Sales Information

RIS / Press fitting transition from the old to the new system

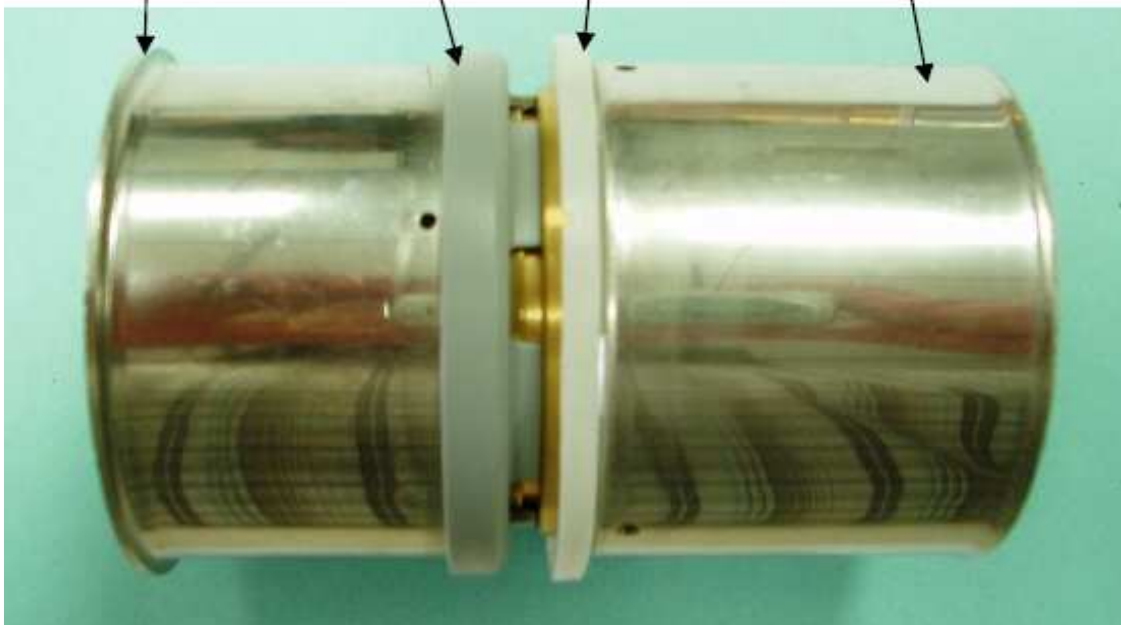
On one side the fitting is build (as supplied before) with a white fixation and an attached sleeve for the old version. On the other side you see the sleeve with the pressured combination ring and flanging PressCheck for the jaw fixation for the new system.

New PressCheck contour and sleeve with flanging and combination ring

Production run contour and sleeve until 31.03.08 with fixing ring and pressured sleeve

Of course the side with the production run contour (until 31.03.08) can be pressed with the reconverted press loop. Therefore the press loop has to clasp the sleeve in centre.
